Mitigation Plan

Mushroom Meadow Mitigation Site

Caswell County, North Carolina
Roanoke River Basin HUC 03010104
DMS Project ID No. 100192
Full Delivery Contract No. 200204-01
USACE Action ID No. SAW-2021-00348
NCDWR No. 20210400, V1

Subject: Mitigation Plan
Mushroom Meadow Mitigation Project, Caswell County
Roanoke River Basin HUC 03010104
USACE Action ID SAW-2021-00348/NCDWR 20210400, V1

**Figure 3: Existing Conditions
Mushroom Meadow Mitigation Site
Roanoke 03010104
Caswell County, North Carolina
December 2022**

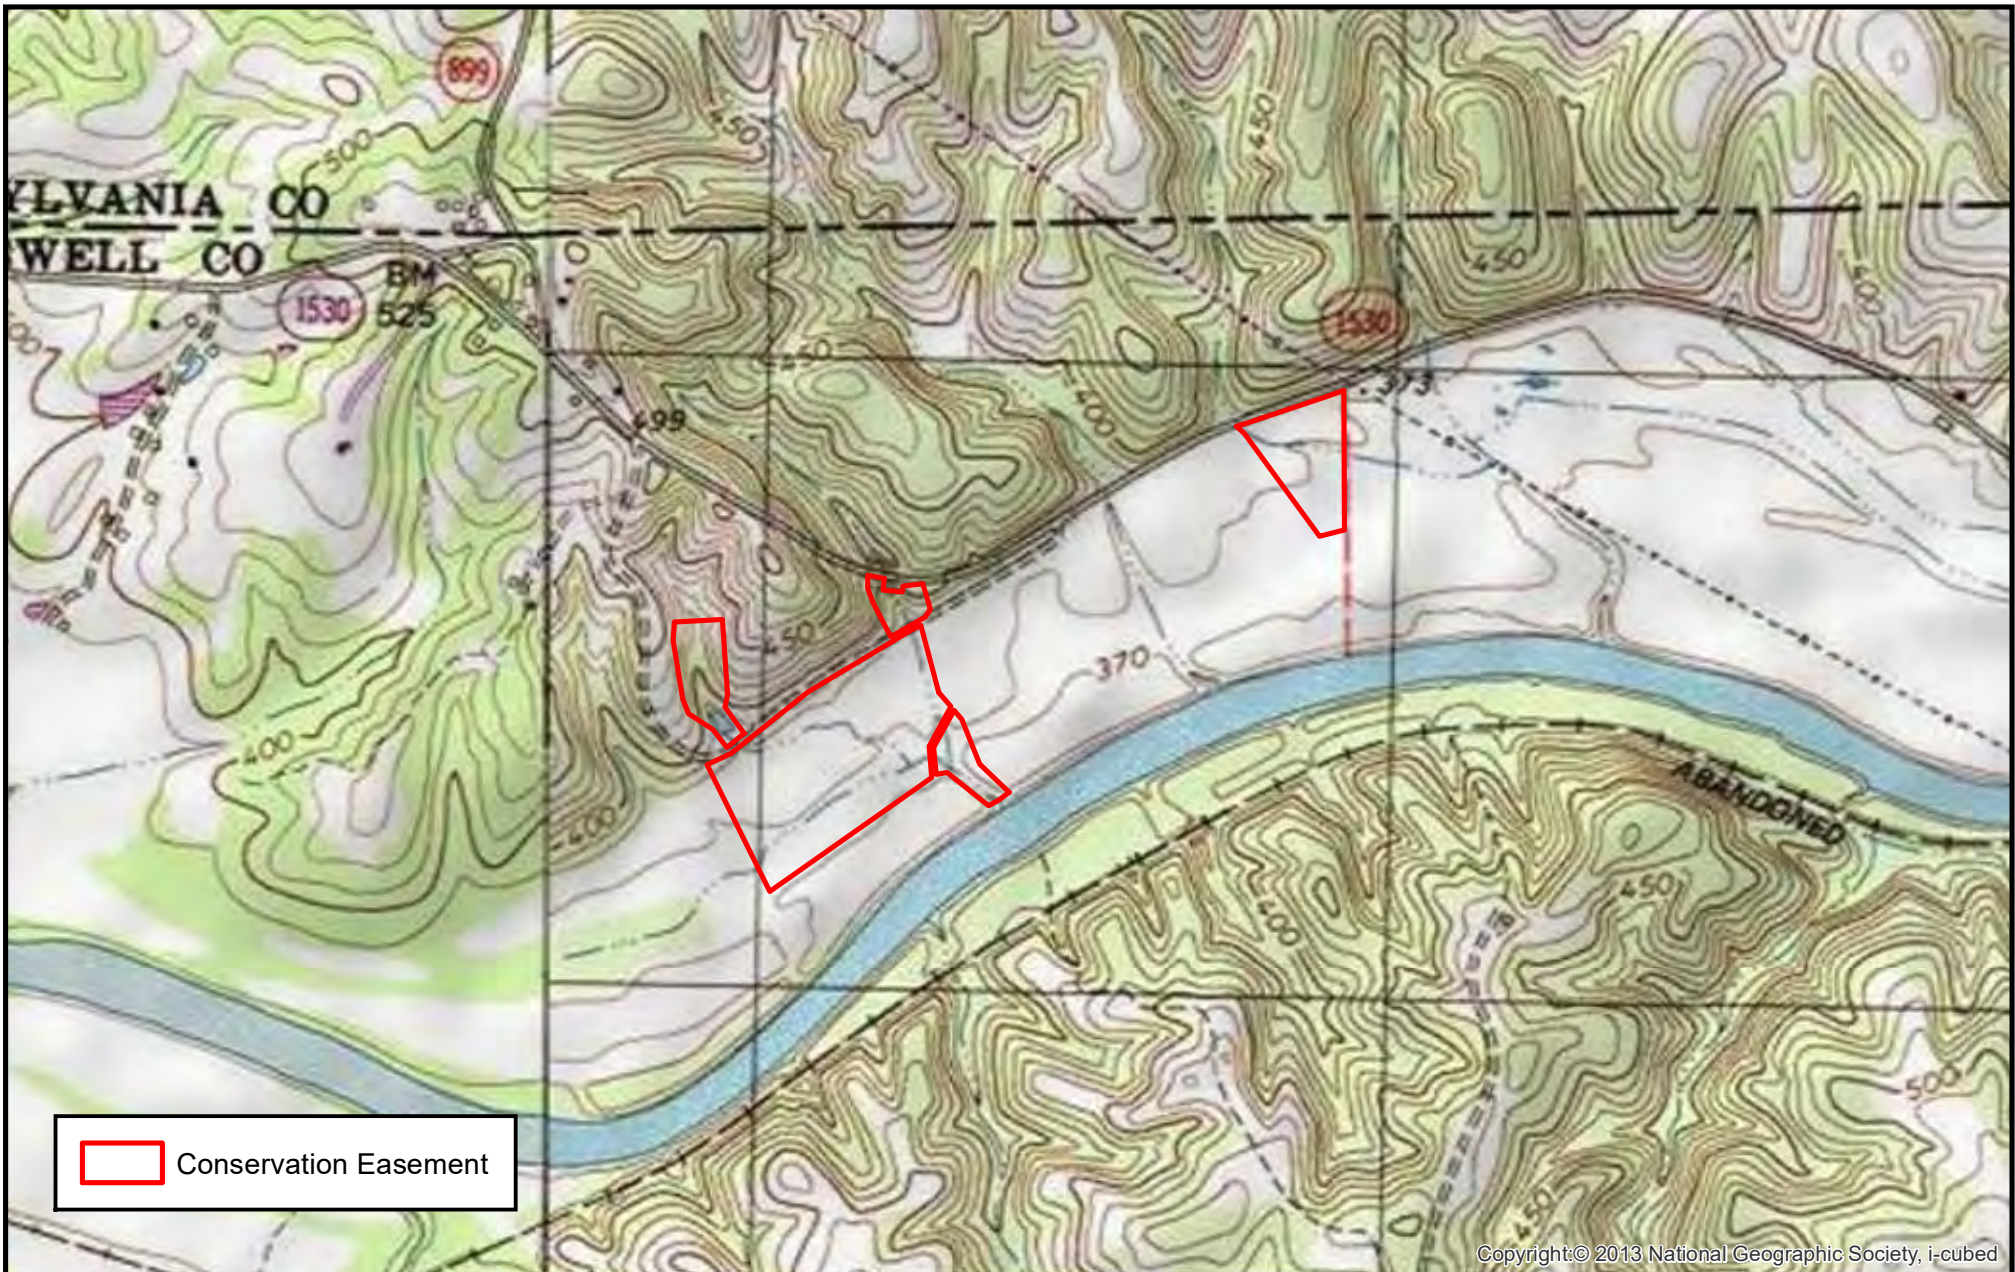
22. Figure 3 – Please callout UT1A, previously identified in Table 2. Also, please add a property boundaries layer to this figure (or another figure). **Added UT1A callout and a parcel boundary.**

Figure 5: Web Soil Survey Map
Caswell County, North Carolina

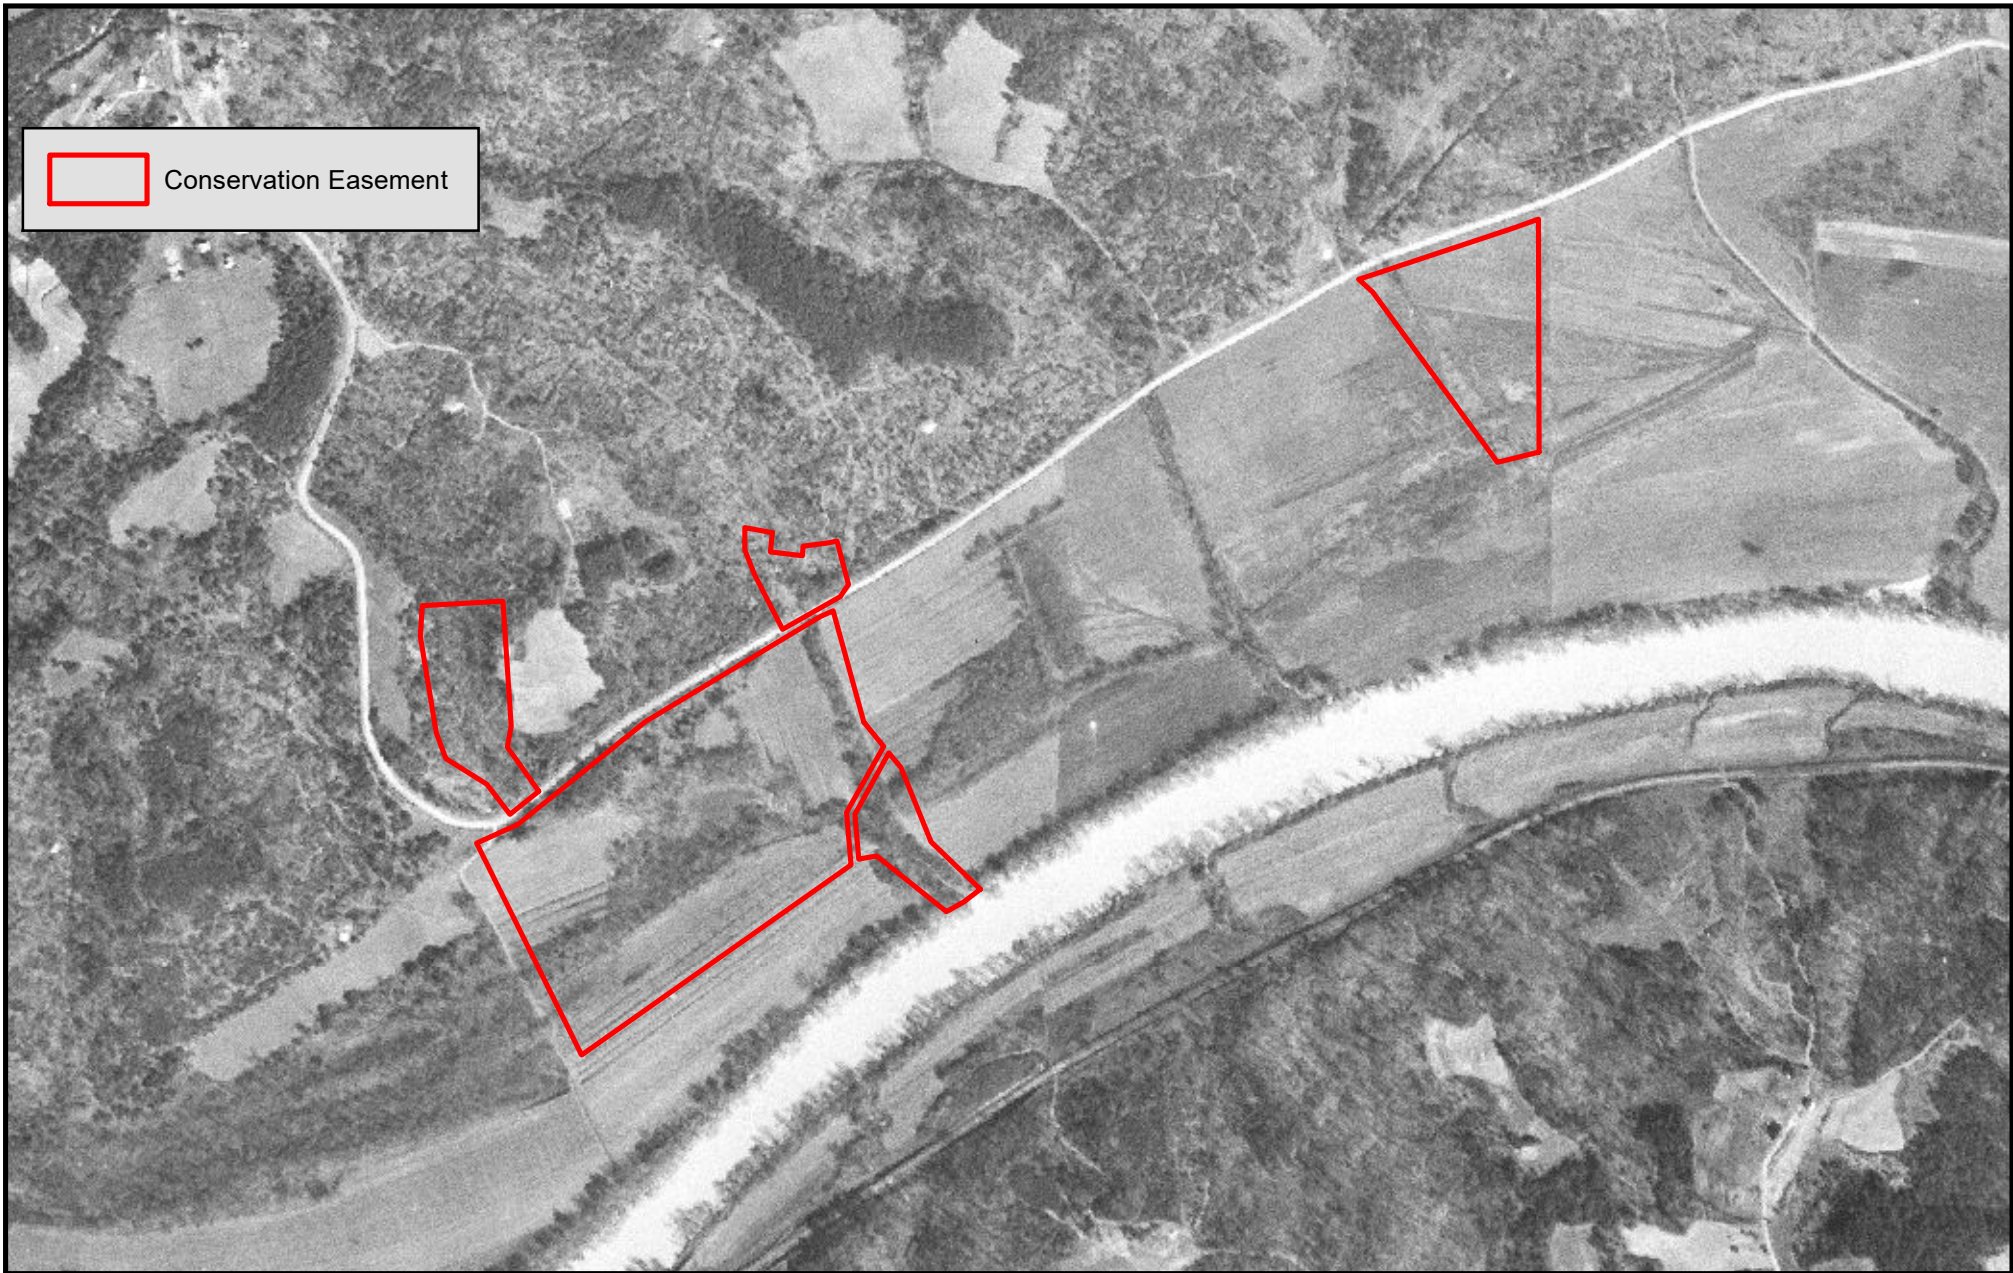
4. Figure 5: Please amend the soils map to include the portion of the easement that includes UT2 Reach 1. Updated Figure 5 with entire conservation easement.

Figure 8: Mitigation Areas
Mushroom Meadow Mitigation Site
Roanoke 03010104
Caswell County, North Carolina
December 2022
 NC Onemap 2021 Aerial

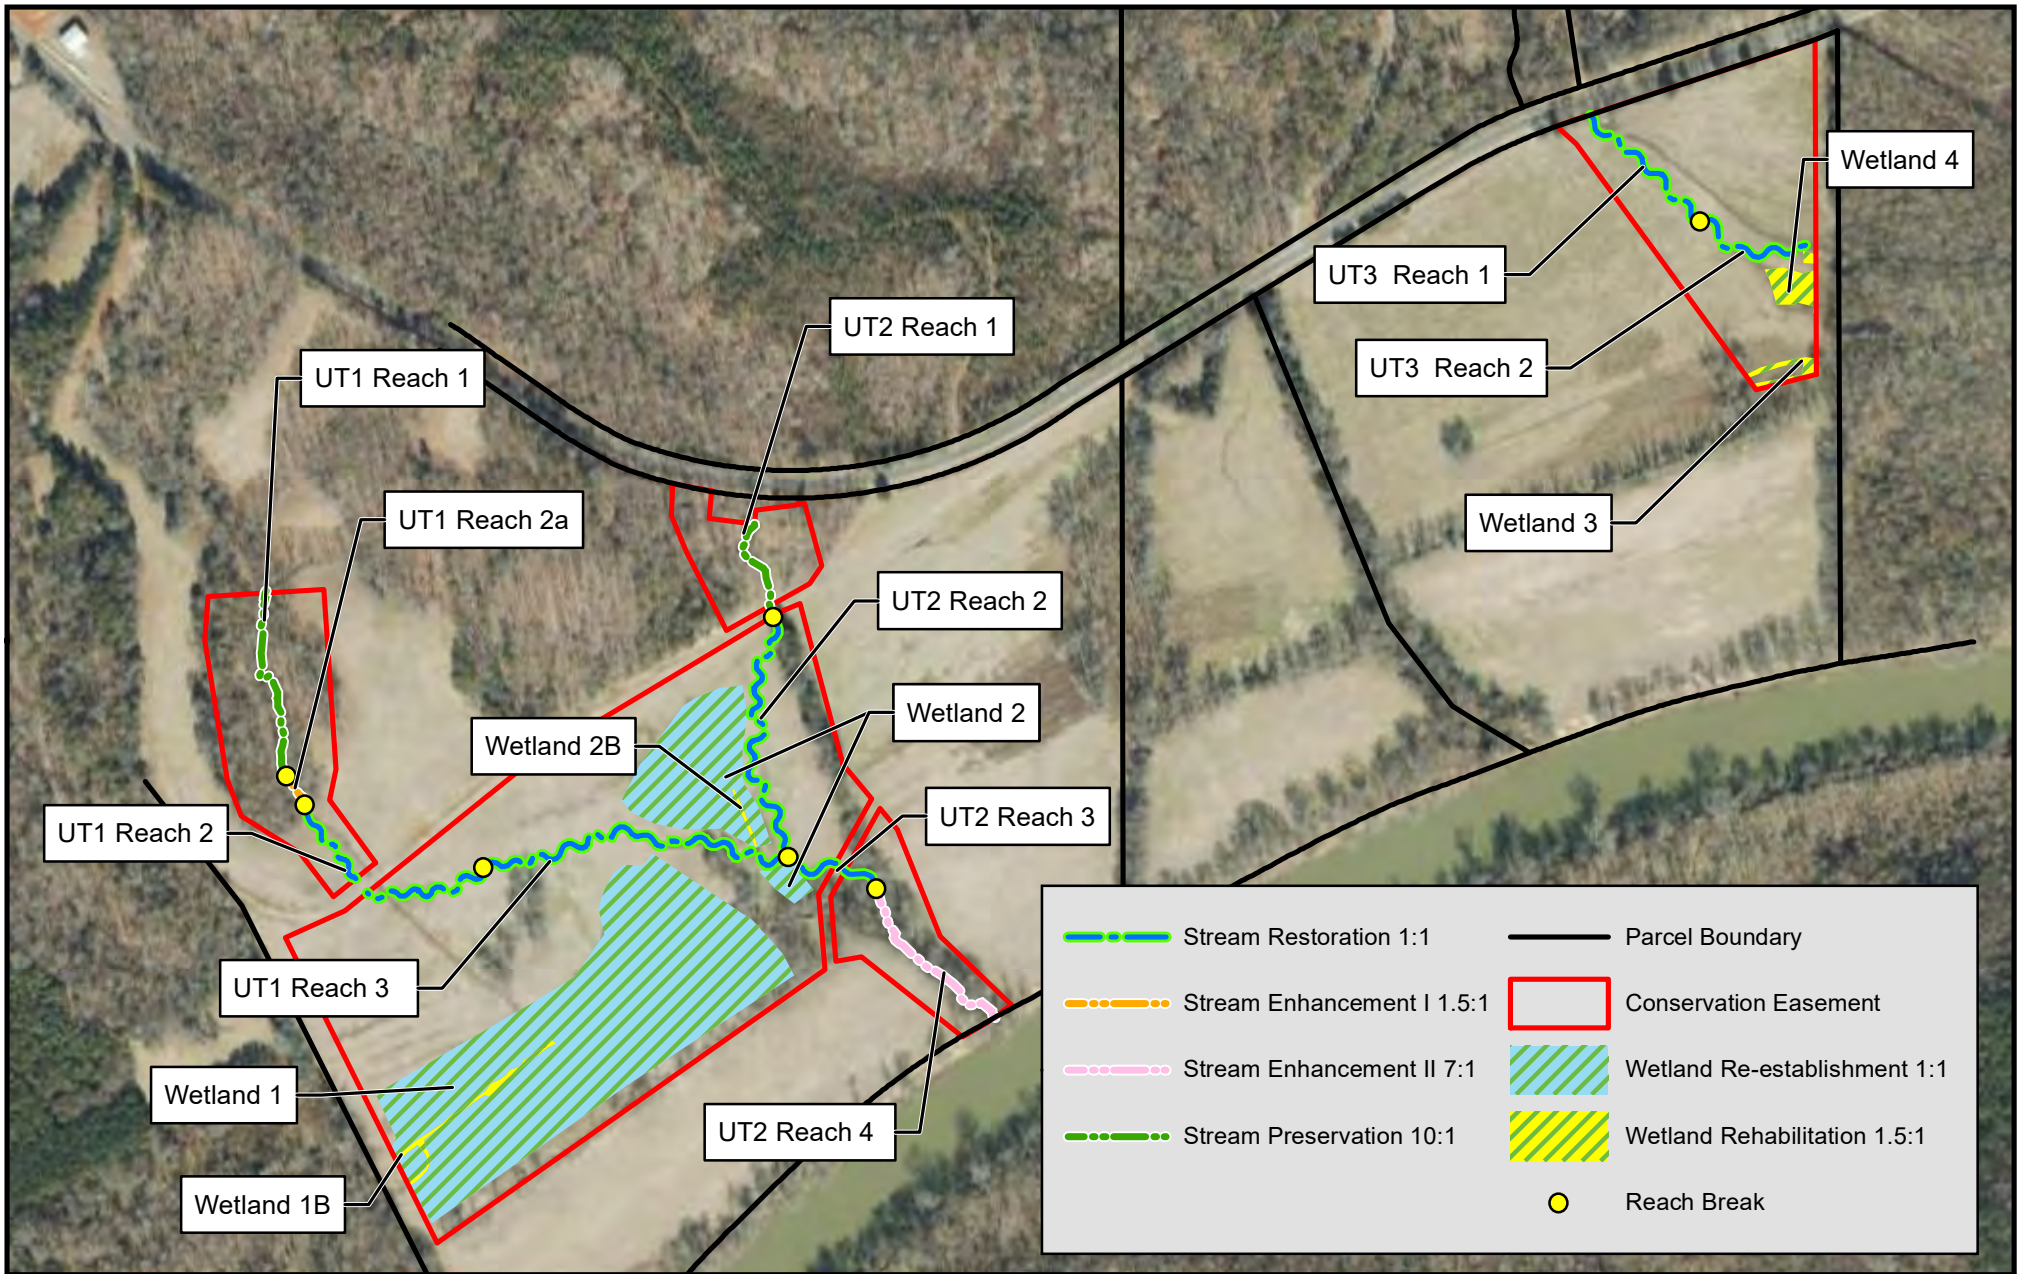
23. Figure 8 – For the future projects and monitoring report CCPVs for this project, it would be helpful if the stream icon for restoration is color-coded blue and preservation is green. Please add the corresponding ratios to the figure legend. **Changed the colors on Figures 8 and 9 and added ratios to legend.**

Figure 9: Monitoring Plan
Mushroom Meadow Mitigation Site
Roanoke 03010104
Caswell County, North Carolina
December 2022
 NC Onemap 2021 Aerial

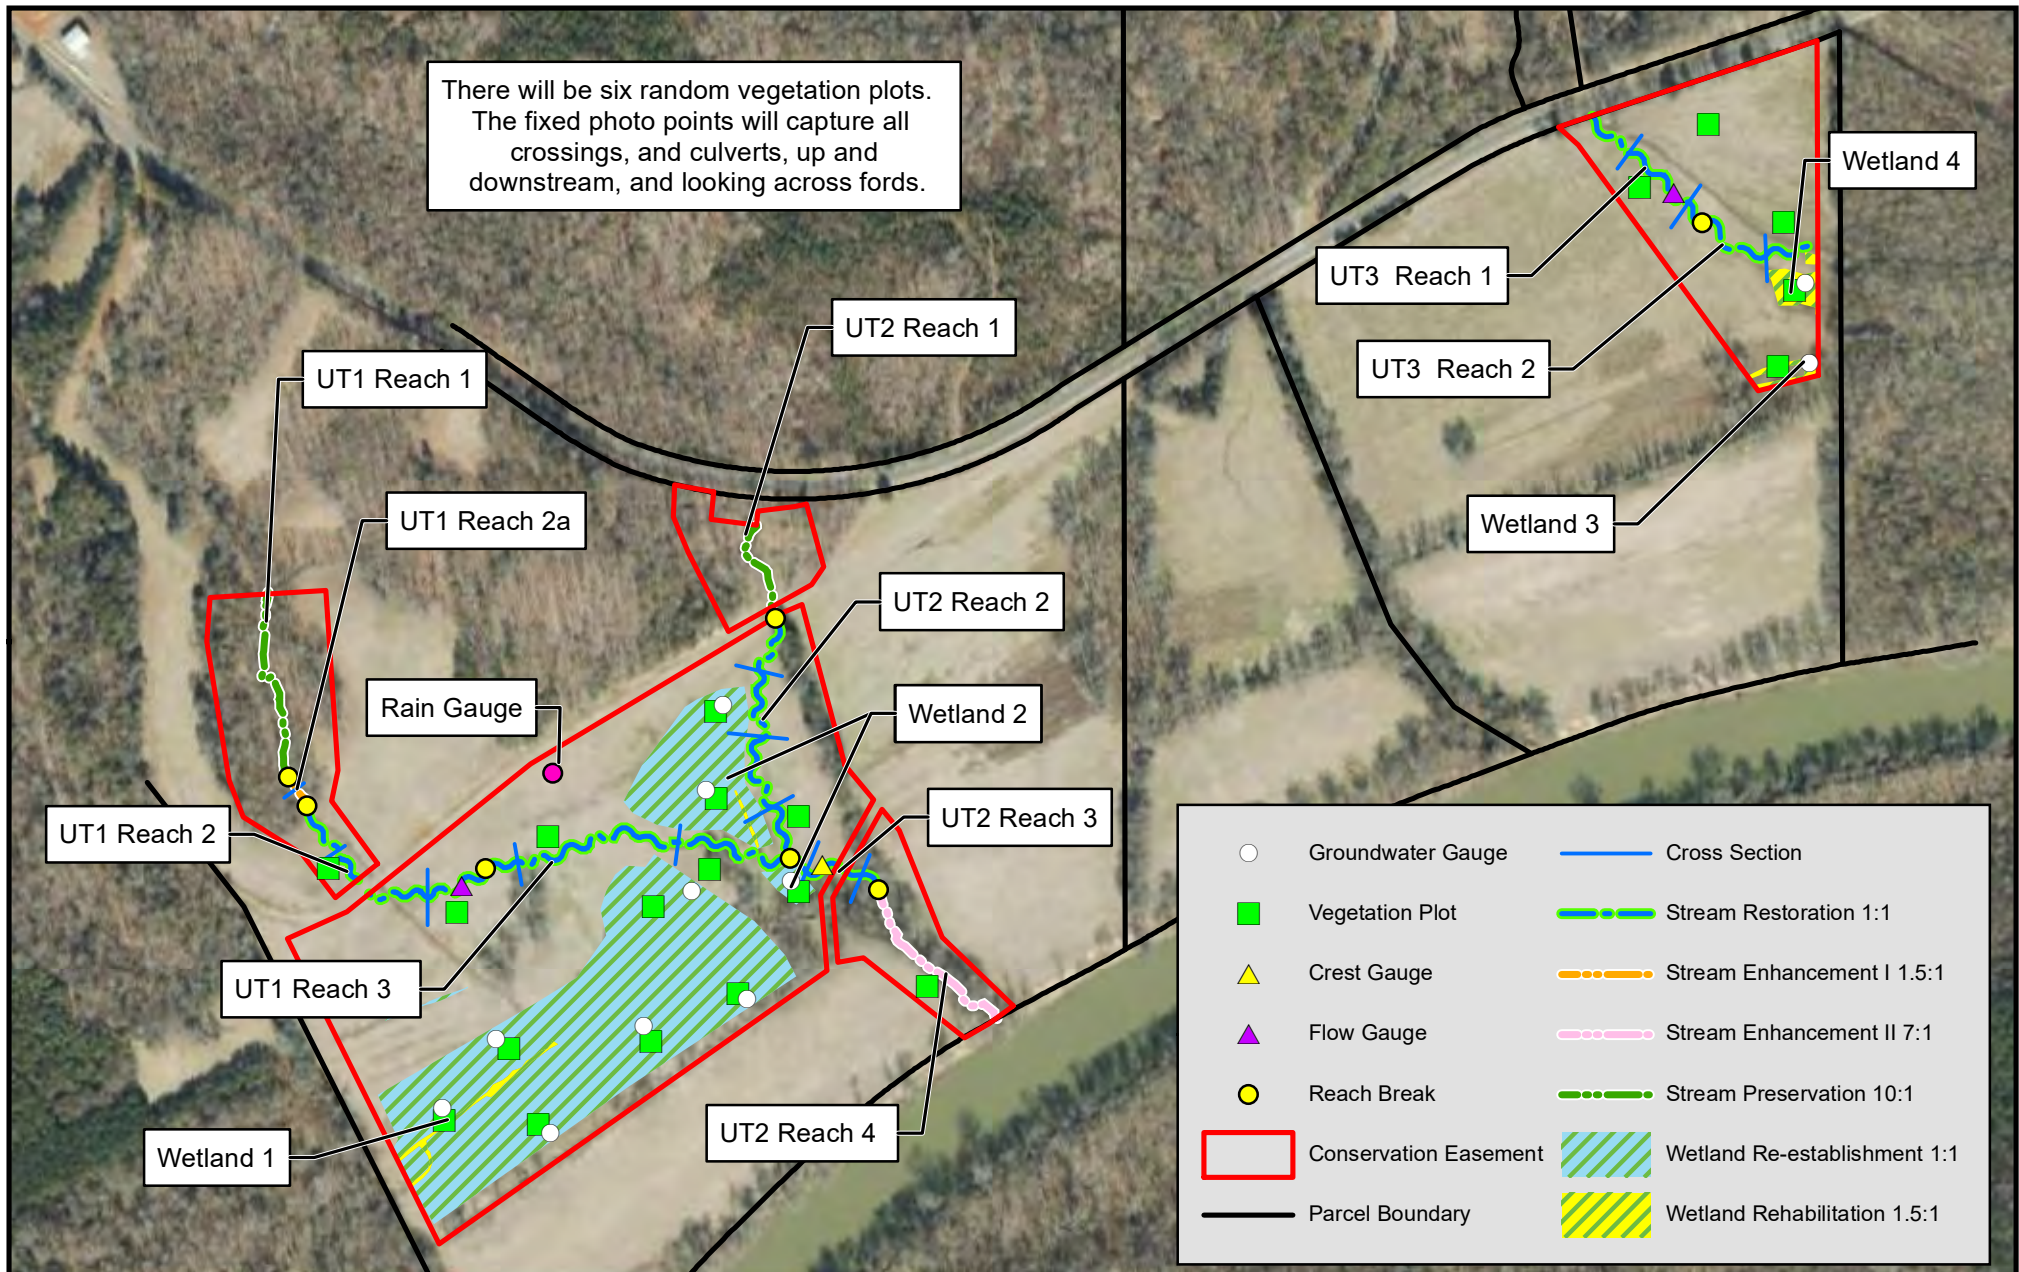
24. Figure 9 -
 - a. Please differentiate between crest and flow gauges. **Changed symbology for crest and flow gauges.**
 - b. All flow gauges should be located within the upper one-third of the reach. Please shift the flow gauges upstream to UT1 Reach 2 and UT3 Reach 1. **Moved flow gauges upstream.**

- stream channels. **No gauges will be installed over filled ditches or stream channels.**
- d. DWR requests an additional groundwater gauge in Wetland 2 near the credit area/upland boundary. DWR also requests location shifts for four of the groundwater gauges and one veg plot (see figure markup). **Moved four gauges, added one and moved one veg plot.**

- e. Please add a figure note regarding additional random veg plots and fixed photo points. **Added note to Figure 9.**
25. Sheet PSH-01.3 – Looking at the property boundary east of UT3 and Wetlands 3 & 4, why was the proposed easement setback from the property line? This appears to be a missed opportunity to capture additional wetland and stream on the site. **The landowner specifically requested there be a setback from the property boundary.**

3. Figure 9:
 - a. Random veg plots should be shown differently from the permanent plots. Please plan to include a random plot along the northern border of the easement north of UT1 Reach 3 in the steeper area. Random veg plots are not shown on Figure 9 and will change each year. At least on random veg plot will be north of UT1 Reach 3.
